Issue List

05-26-25 CAVA WARWICK, RI

Issue Name : 1. RTUs On Incorrect Curbs

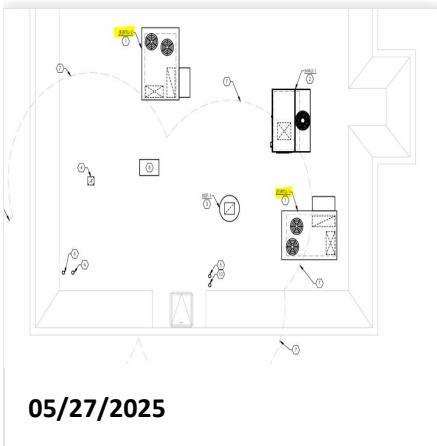
Description : The "48FCD09" unit is serving the Dining Area and the "48FCDN12" unit is serving the Kitchen. Per the mechanical plans, the larger unit is supposed to serve the Dining Area. To achieve proper cooling of the space, these units will need to be swapped.

- **05/27/2025 National TAB - Stephen Tassinaro**
 - Currently both units will be balanced to 400CFM/Ton respectively. This will not match the designs shown on the mechanical plans since there is now 4000CFM in the kitchen instead of 3400CFM. And 3400CFM in the dining room, instead of the original 4000CFM. All diffusers will be proportionally balanced.

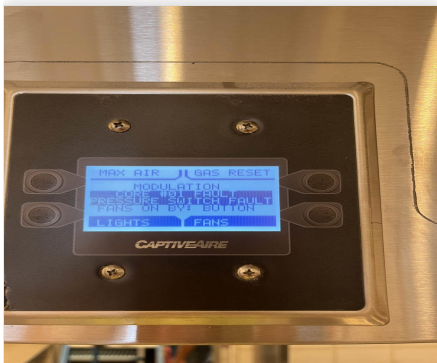
Issue Name : Grease Duct Not Secured to Curb
Description : Duct top plate flanges to the edges of the curb, but it is not secured. This allows for movement of the grease duct and grease will accumulate.
Created By : National TAB **Assigned To :** National TAB - Will Turnbough
Status : Open
Priority : Medium **Asset Tag :**
Originated Date : 05/29/2025 - Stephen Tassinaro - National TAB

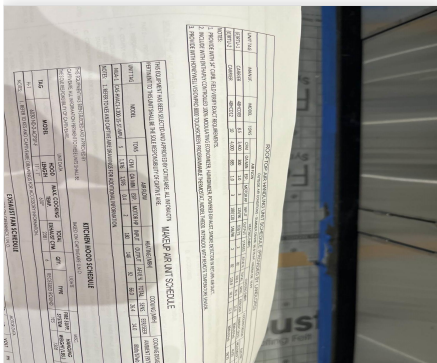
Issue Name : Hood "Core #01 Fault"
Description : The kitchen hood HMI is displaying "Core #01 Fault". This did not effect the balancing of the hood.
Created By : National TAB **Assigned To :** National TAB - Will Turnbough
Status : Open
Priority : InfoOnly **Asset Tag :**
Originated Date : 05/27/2025 - Stephen Tassinaro - National TAB
